SCI-823-0.00

FLATWOOD-FALLEN TIMBER ROAD

(C.R. 184) OVER S.R. 823

STRUCTURE TYPE STUDY SUBMITTAL

ELEVATION ALONG & SURVEY AND CONSTRUCTION FLATWOOD-FALLEN TIMBER ROAD (C.R. 184)

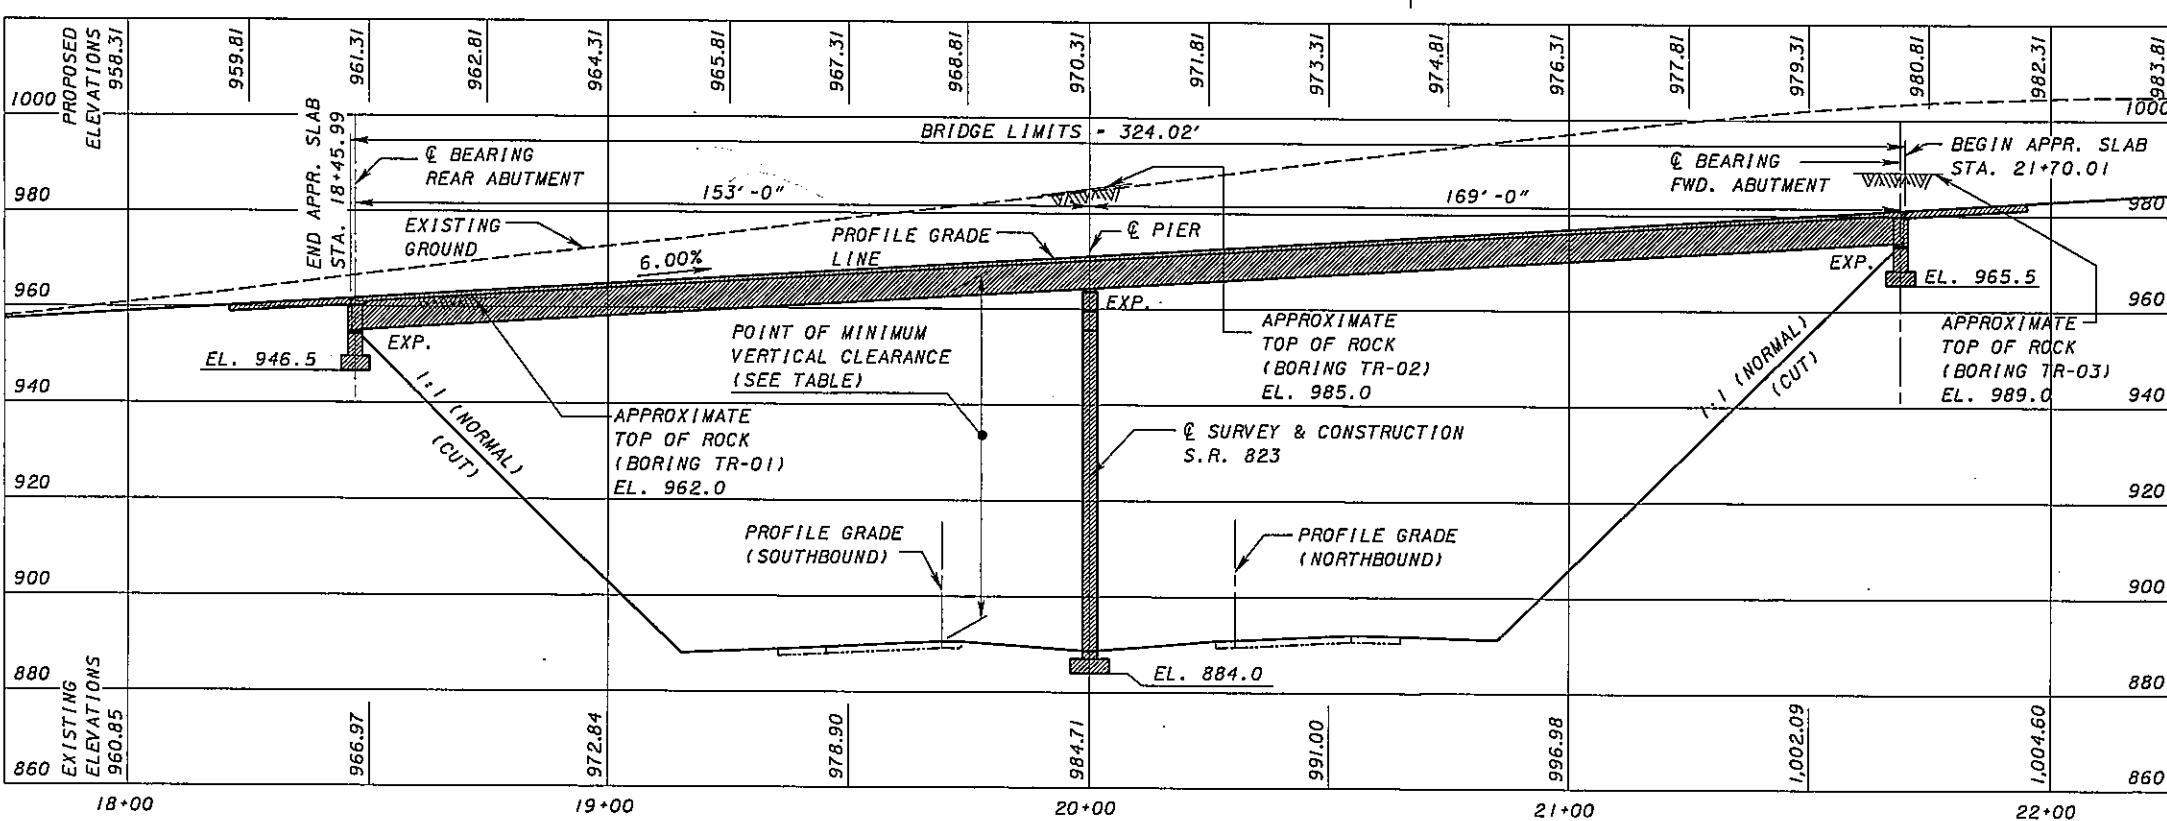
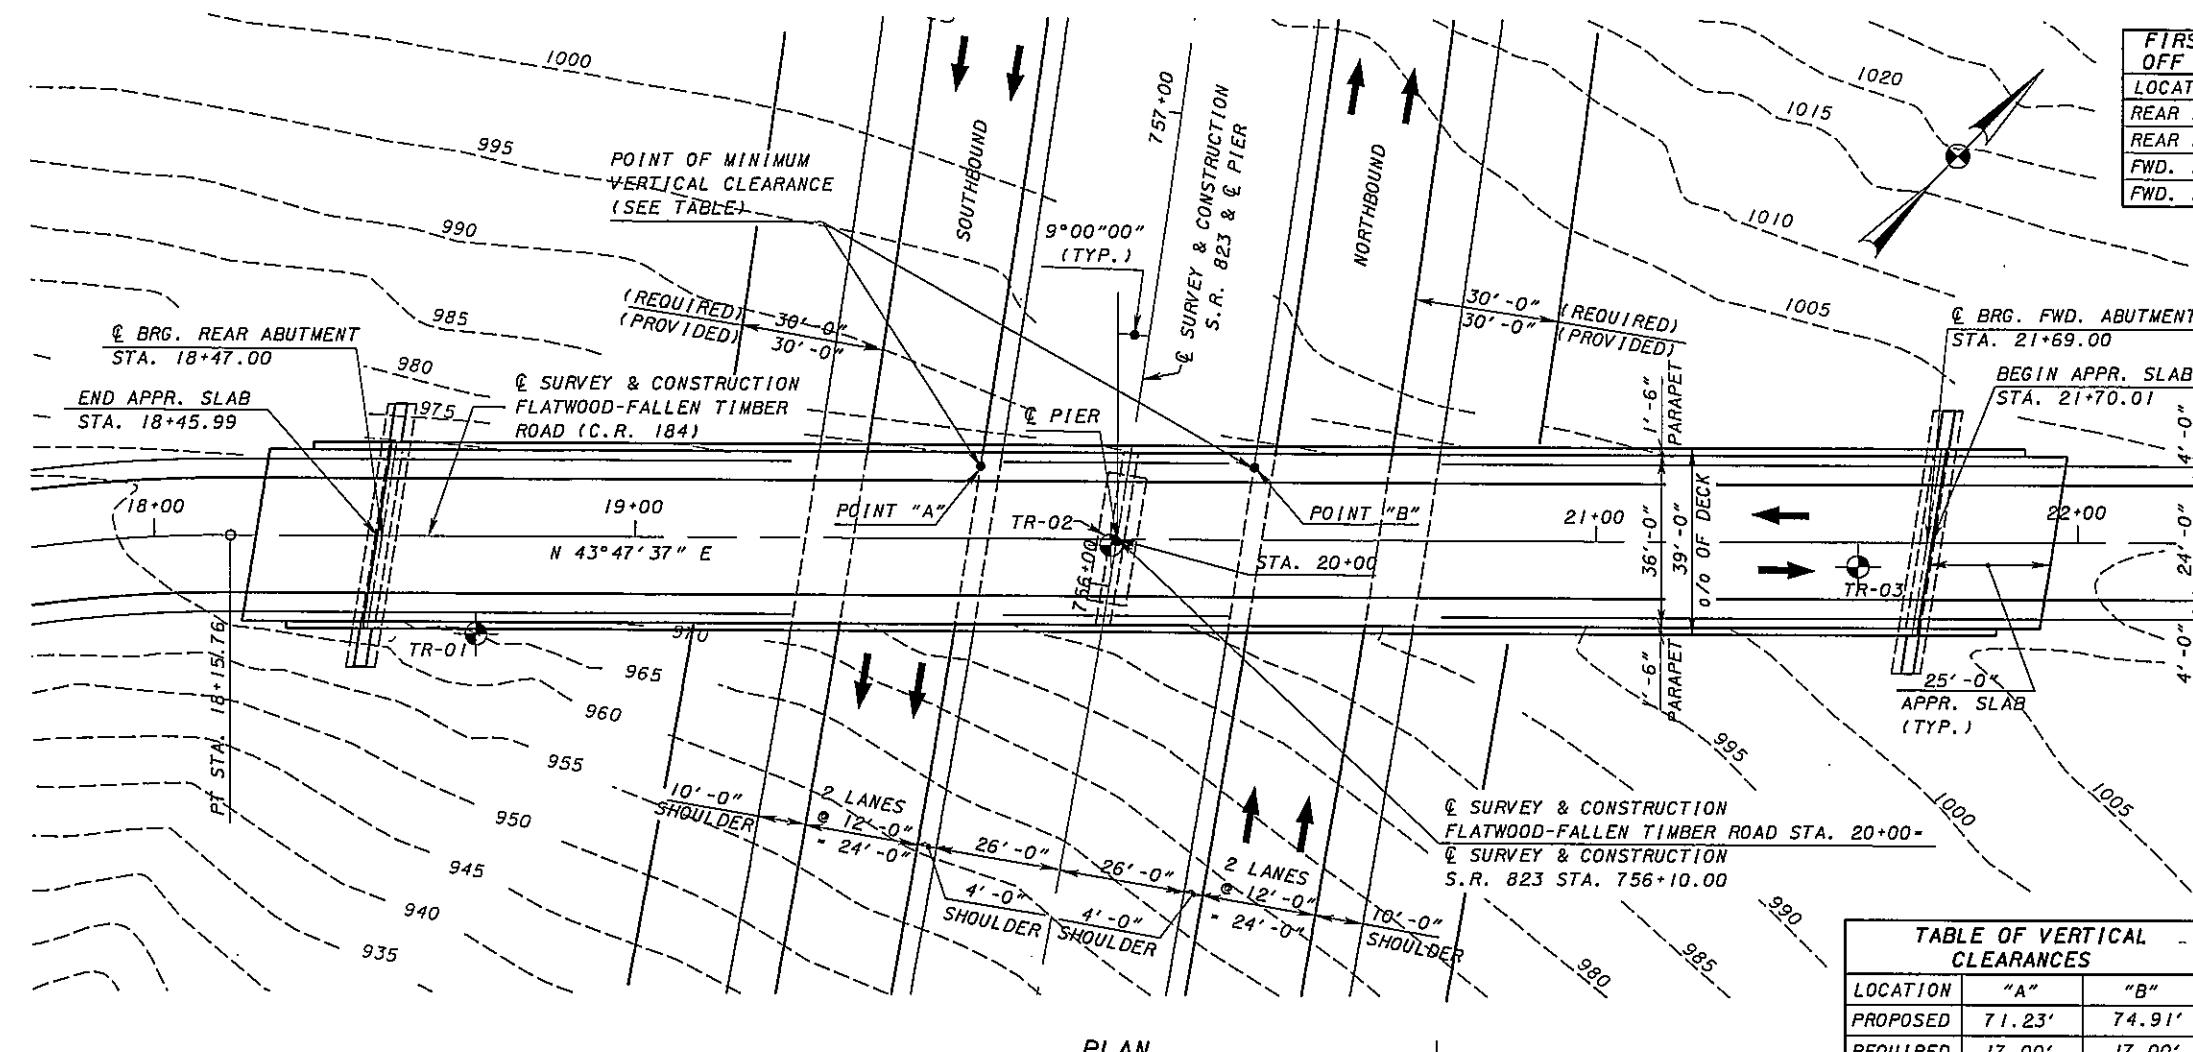
ASK CONSULTANT TO INVESTIGATE
EXISTING SUBSTRUCTURES.
